Project	IEEE 802.16 Broadband Wireless Access Working Group	
Title	Changes between 802.16.1 Functional Requirements (IEEE 802.16s-99/00r1) and 802.16.3 Functional Requirements (Proposed) (IEEE 802.16.3-00/02r0)	
Date Submitted	2000-03-27	
Source	Brian Petry 3Com 12230 World Trade Dr San Diego, CA	Voice: (858) 674-8533 Fax: E-mail:brian_petry@3com.com
Re:	At 802.16 Session #6, the sub-10 study group authorized Brian Petry to create a document that specified the differences between the 802.16.1 Functional Requirements and George Fishel's "first cut" at 802.16.3 Functional Requirements.	
Abstract	The document is the output from MS-Word's "Compare Documents" feature, that automatically created red-lined differences between the two documents.	
Purpose	This document is meant to assist 802.16.3 Functional Requirements reviewers to see exactly what changes George made to the 802.16.1 Functional Requirements.

Proposed Functional Requirements Draft Document for Sub 10 GHz Study Group

Figure 2-1: System Showing a Base Station Mounted on a Tower

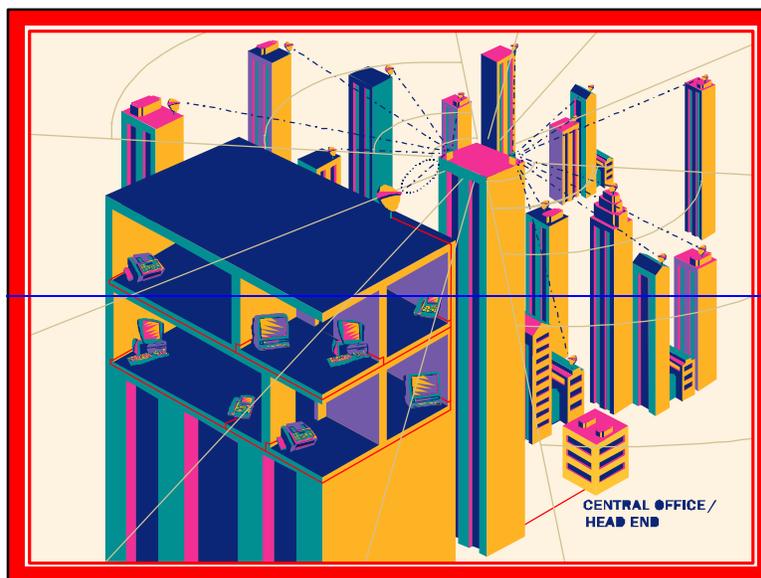
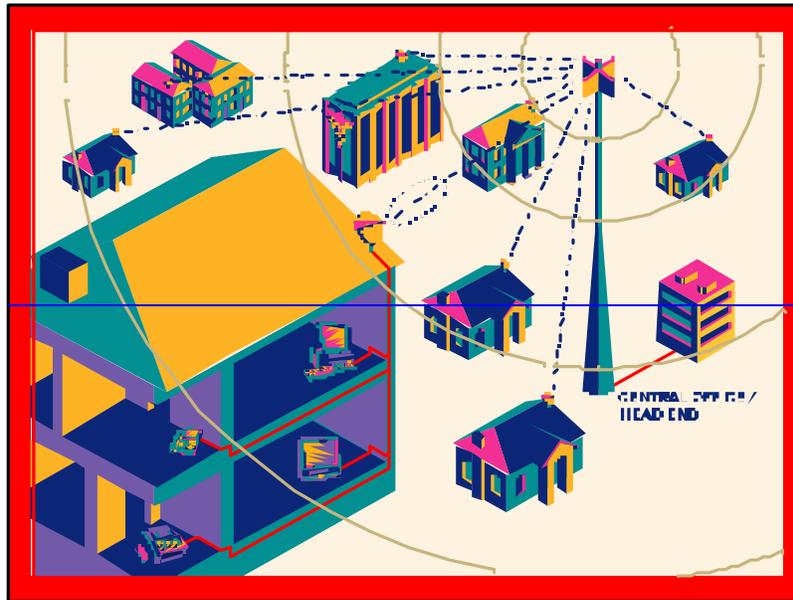
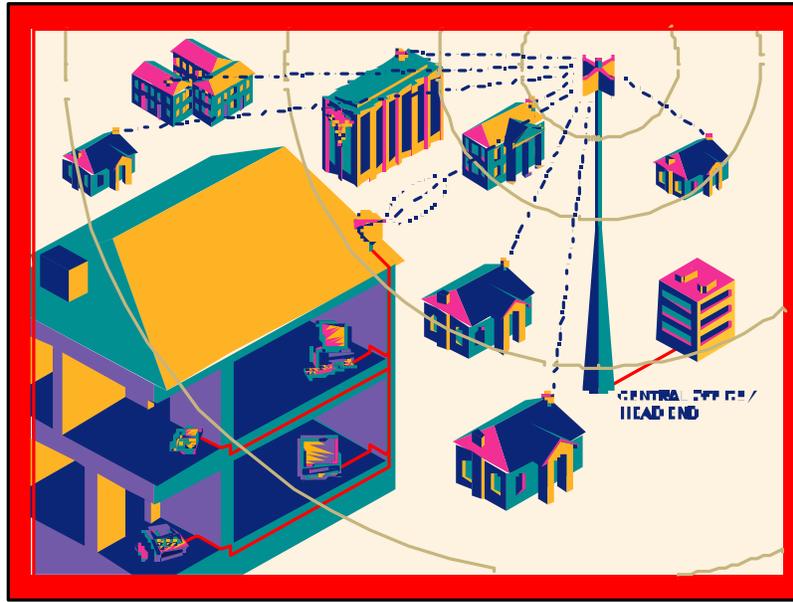
22 As mentioned in section, an 802.16.3 "system" constitutes: an 802.16.3MAC and PHY
 23 implementation, in which at least one subscriber station communicates with a base station via a
 24 radio air interface (an 802.16.3 system), and services transported by the MAC and PHY
 25 protocols. Specific applications of the 802.16.3 point-to-multipoint (P-MP) radios include 2.1
 26 to3.5 GHz, but the standard is more generally applicable to the range from 1 GHz to 10 GHz.
 27 The standard is used to connect a base station to one or more subscriber stations [4][9]. Radio
 28 communications in the above range require near line-of-sight (NLOS) between a base station and
 29 subscriber station. NLOS operation may include partial blockage by foliage which contributes to
 30 signal attenuation and multipath effects. Figure 2.1 depicts a typical 802.16.3 systems. 802.16.3
 31 systems SHALL be deployable in multiple-cell frequency reuse systems and single cell (super

- 1 [cell\) frequency reuse systems. The range of 802.16.3 radios varies with transmit power, NLOS](#)
- 2 [blockage, availability requirement, and atmospheric conditions.](#)

Note, in concern for simple terminology, an 802.16.3 system consists of one base station radio and one or more subscribers. Thus, an 802.16.3 system also defines 802.16.3 base station and subscriber station radios that communicate using the 802.16.3 MAC and PHY protocols. The base station radio SHALL be P-MP, radiating its downstream signal with a shaped sector antenna achieving broad azimuthal beam width to “cover” a prospective number of subscribers. An isolated omnidirectional antenna should be treated as the degenerative version of the sectored operation. Each subscriber station employs a highly directional radio pointed at the base station. Note that with this arrangement, direct radio communications between subscriber stations is not possible. Furthermore, the 802.16.3 system does not define radio communications between base stations. Since the base station radios are “sector oriented,” multiple base station radios will likely, in practice, be co-located (subject to frequency re-use requirements), and even share physical hardware.

24 Figure 2-3-2: System Reference Points

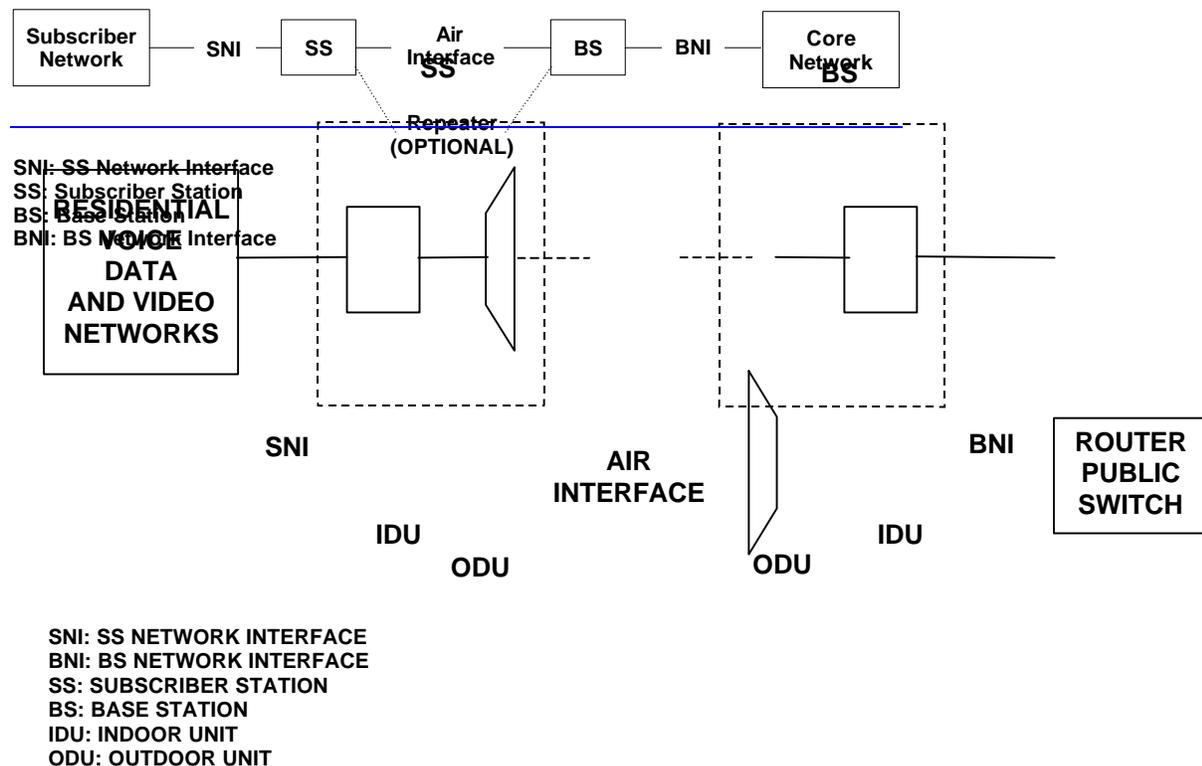
1
2 A single SNI may support multiple ~~subscriber networks: LANs, Voice PBXs, etc. And recall from section~~
3 ~~1.2 that the SNI may support multiple paying subscribers, such as within a multi-tenant office building or dwelling,~~
4 ~~residential networks: voice, data and video, etc.~~ A base station interfaces ~~to~~may support one or
5 more core networks through one or more BNIs. For the purposes of ~~802.16.1, 802.16.3~~, the SNI
6 and BNI are abstract concepts. The details of these interfaces, which are sometimes called inter-
7 working functions (IWFs), are beyond the scope of this document and are not specified by the
8 forthcoming interoperability standard [20] [17]. Since many subscriber and core network
9 technologies are possible, many different IWFs are conceivable. The simplified reference
10 model, serves to discuss the impact of core network technologies and ~~bearer~~ services (see section

11 ~~3.1~~) on the requirements of ~~802.16.1, 802.16.3~~ protocols by drawing focus to the air interface and
12 the immediate requirements imposed by the surrounding networks. The standard (e.g.,
13 MAC/PHY protocols) SHALL describe common access protocol(s) and comm_on modulation
14 technique(s).
15
16
